**PLANNING UNIT REPORT**  
**DEPARTMENT OF PLANNING AND DEVELOPMENT**  
**of July 18, 2006**

**RE: I.D. # 04004: Zoning Map Amendment I.D. 3202, rezoning 203 Wisconsin Avenue from R6 and R6H to C2 and I.D. # 04005: Zoning Map Amendment I.D. 3203 & 3204, rezoning 22 E. Dayton Street and 208 N. Pinckney Street from R6H and C2 to PUD-GDP-SIP**

DATE: June 14, 2006  
TO: Plan Commission  
FROM: Larry D. Nelson, P.E., City Engineer  
SUBJECT: 203 Wisconsin Avenue Demolition/Rezoning

SHEET NO.  
C202

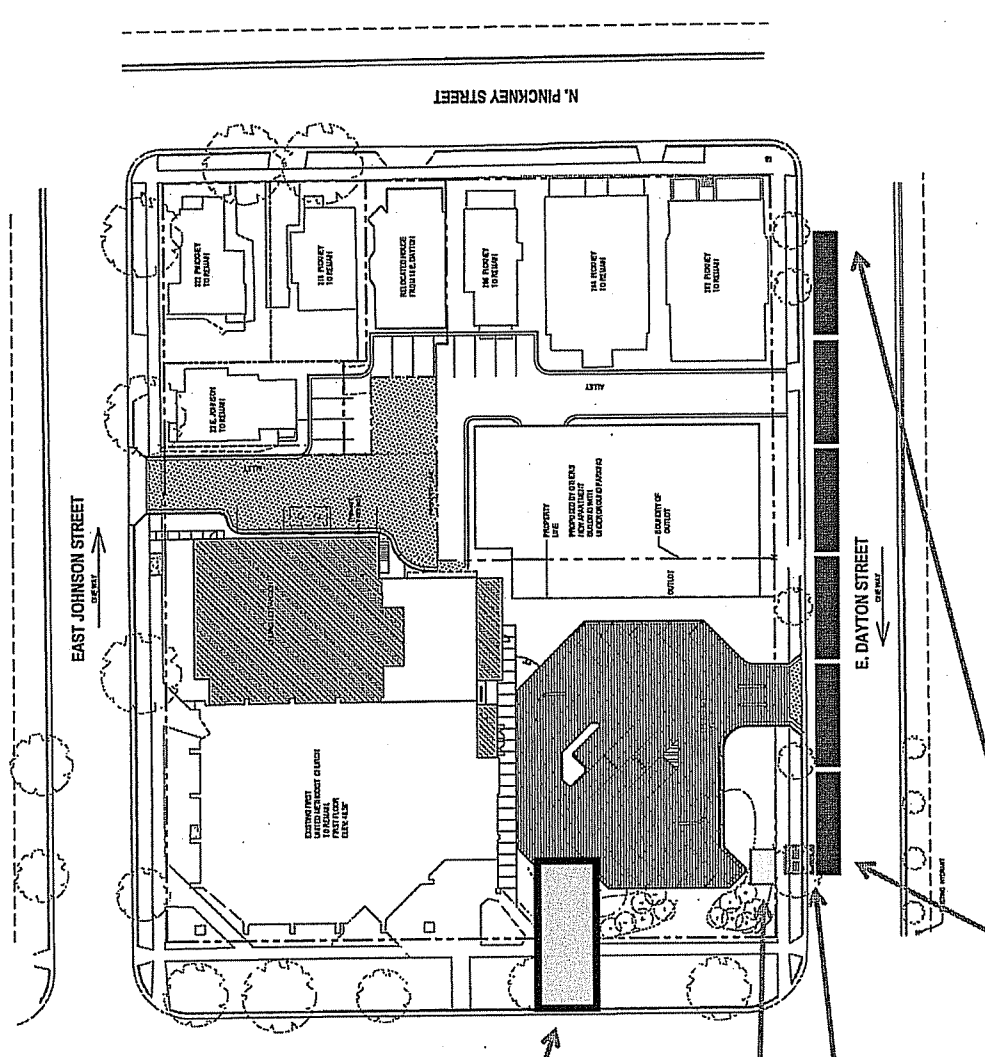
1. Metro Transit recommends rejection of the current plans, as they relate to the proposed driveway access point on East Dayton Street that would serve the proposed surface parking lot at the corner of East Dayton Street and Wisconsin Avenue.

- frequency (i.e. every weekend, all summer long, etc.)
8. Installation of a driveway access point at the proposed location would severely limit the City's ability to use this block face as an effective bus stop location – both as a regular Outer Ring detour bus stop or more importantly as a permanent boarding point in response to a route relocation such has been questioned in the past. Car traffic accessing the proposed parking lot could face significant delays in both entering and exiting due to the long queue of buses needing to block the driveway as they await their scheduled departure time and transfer passengers. Bus passengers with limited mobility would encounter greater difficulty boarding and exiting buses as they step between the bottom of the driveway apron and the threshold of the bus doorway – as opposed to the shorter height difference between the top of a curb face and the entry of the bus.

9. Given past inquires about using this bus stop location on a more permanent basis, Metro Transit is making the request for an easement on the property that would permit the City of Madison to install bus passenger amenities similar to those found on the Capitol Square. While present usage of the stop may warrant immediate installation of benches (similar to those adjacent the City-County Building and that Outer Ring bus stop location), it would be of significant importance to have this easement space available in the future in order to provide a passenger waiting shelter should the stop ever take on greater importance and usage.

10. Metro Transit would propose that the Plan Commission and Common Council require relocation of the proposed driveway and parking lot such that it takes access off of Wisconsin Avenue instead of East Dayton Street. A more complicated alternative would be a requirement to alter the building footprints on this project and the neighboring site such that an internal circulation route from the proposed parking lot to one of the alleyways leading to East Johnson Street, or the driveway on the opposite end of East Dayton Street near North Pinckney Street, be established.
